Report of the Chief Planning Officer

NORTH AND EAST PLANS PANEL

Subject: PREAPP/13/00521 - Pre-application presentation for the laying out of access and erection of 191 dwellings and commercial/industrial uses at the Millennium Village site, Allerton Bywater.

Drawing Title
Illustrative Masterplan

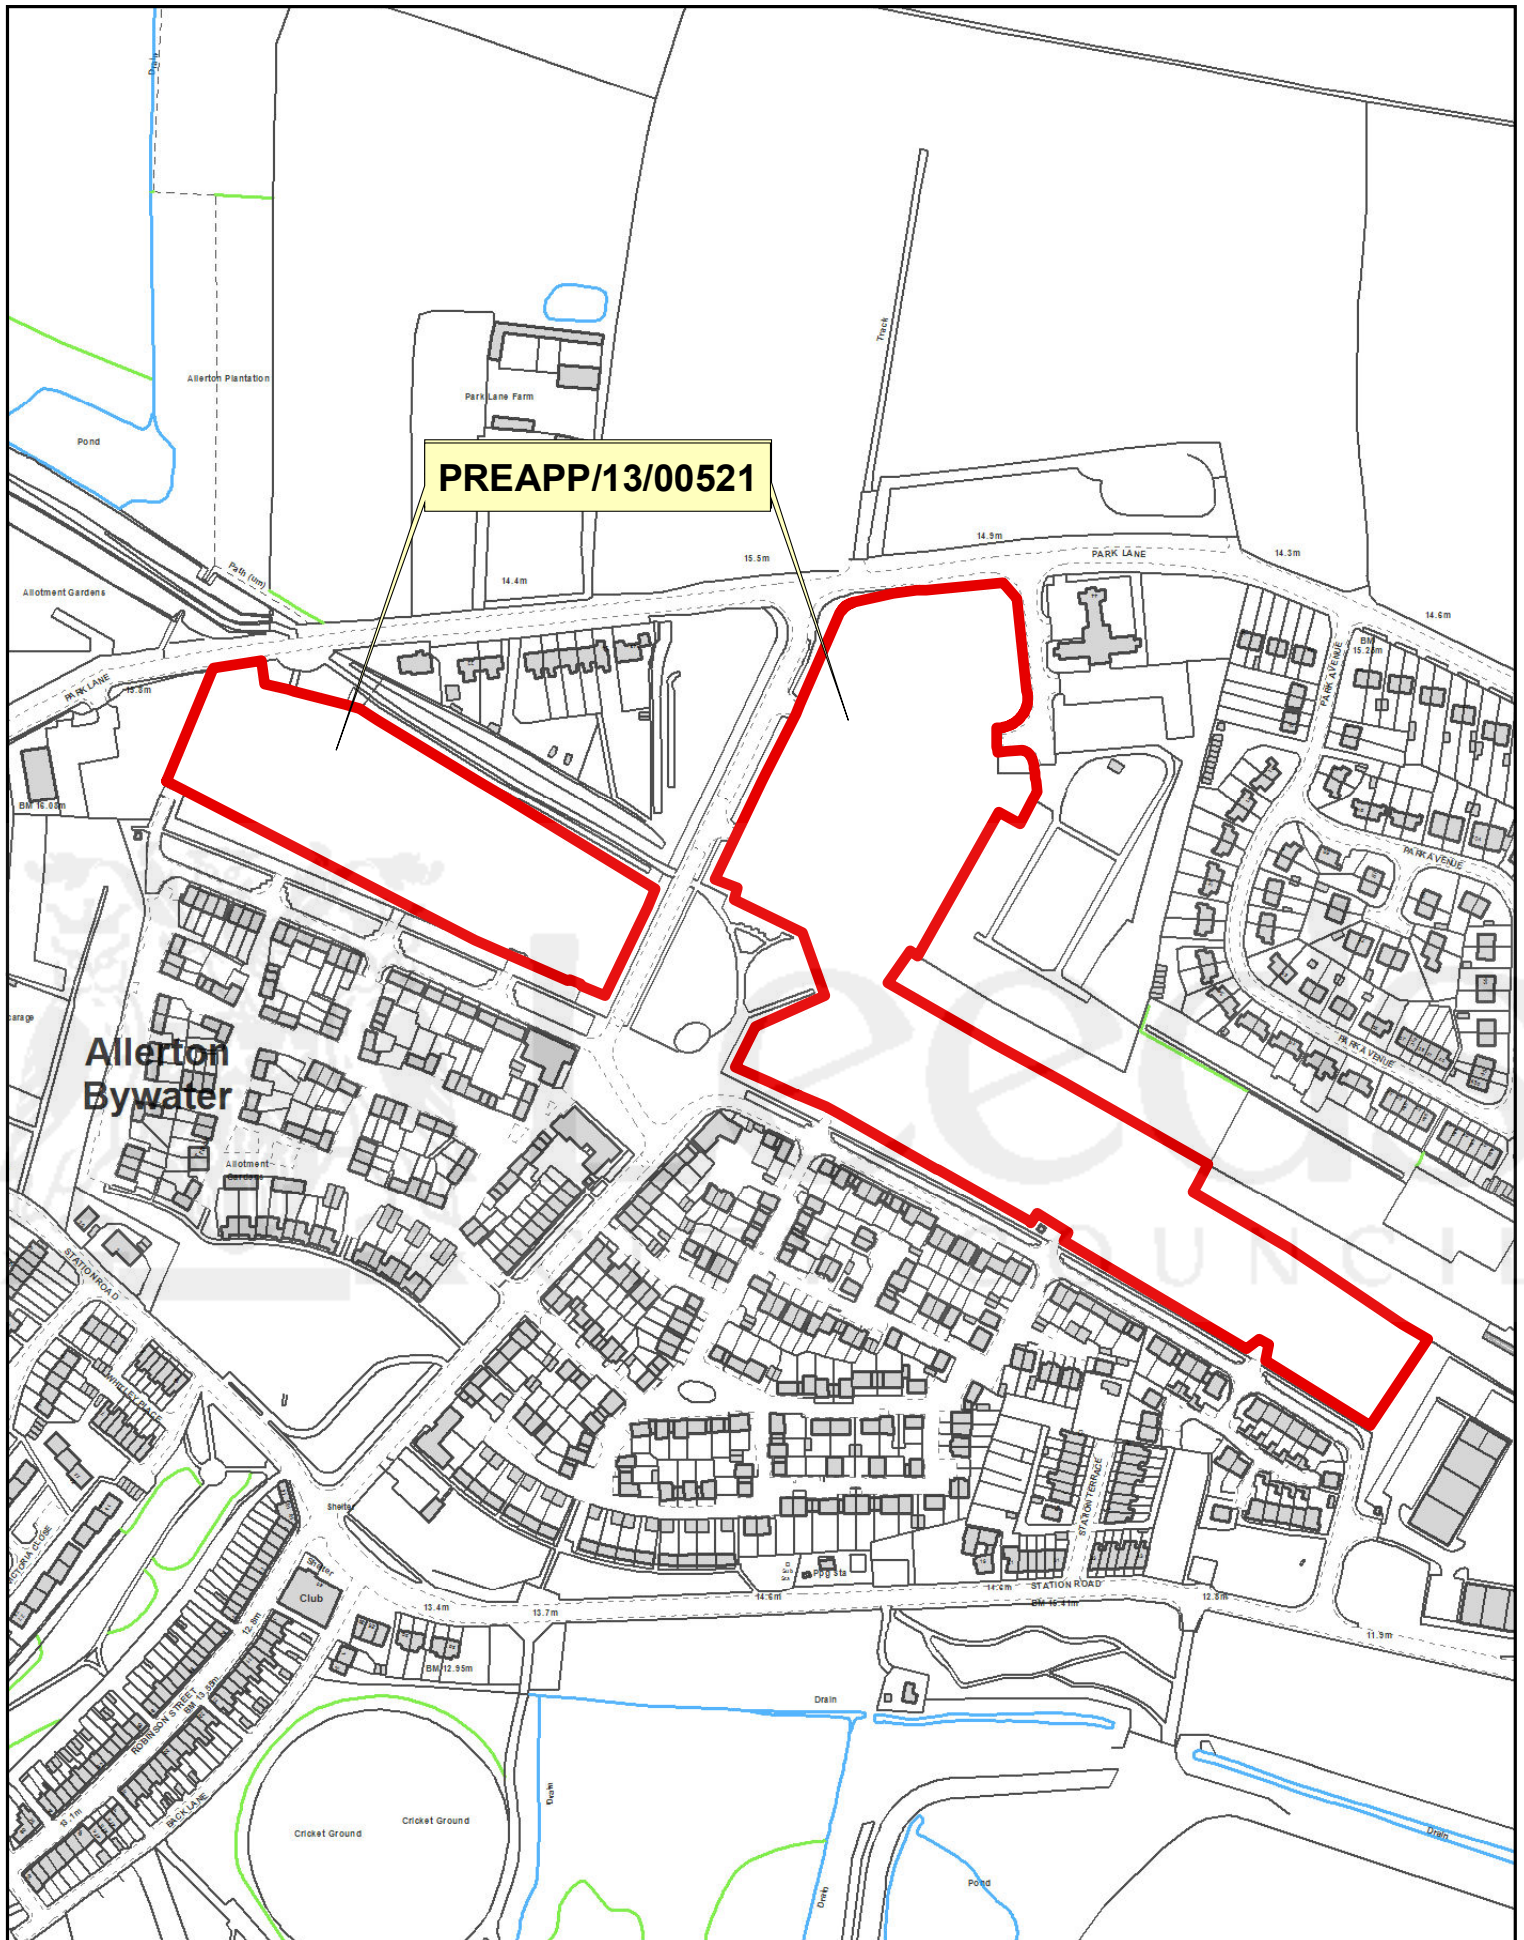
Officers are supportive of many aspects of the general design approach taken but are less convinced about some areas which move away from what the Design Code

originally envisaged (e.g. the site opposite Heigh Moor Way and the blending in of local facilities into Silkstone Square). A number of residential amenity issues are also yet to be satisfactorily resolved.

2. What are Members views on the layout as currently proposed, including the basic design approach taken for the different components and for the space around Silkstone Square?

The neighbouring timber merchant site does not form part of the MV site and is in separate ownership. An area of Network Rail land also lies between part of these adjacent sites. Notwithstanding these issues, officers consider it is appropriate to treat the adjacent site as if it were part of the MV development and due to its own access difficulties need to ensure the current development recognises this.

4. How do Members view the relationship between the site and the neighbouring development in terms of connectivity, access and design approach?

The requirement to provide homezones is contained within the Design Code and is proposed for the residential components of this scheme. In recognition of some problems identified with earlier phases, it is proposed to provide additional parking directly off the main access roads albeit this does raise some adoption issues which are yet to be resolved.

5. Do Members have any comments regarding the use of homezones and the proposal to provide additional off-street parking accessed directly off Flockton Road and Haigh More Way?

The quantum of retail development proposed is greater than originally envisaged and the degree of separation between the MV 'heart' is also more acute.

6. Do Members have any concerns/comments regarding the general mix, scale and proposed siting of the retail, commercial and industrial uses?
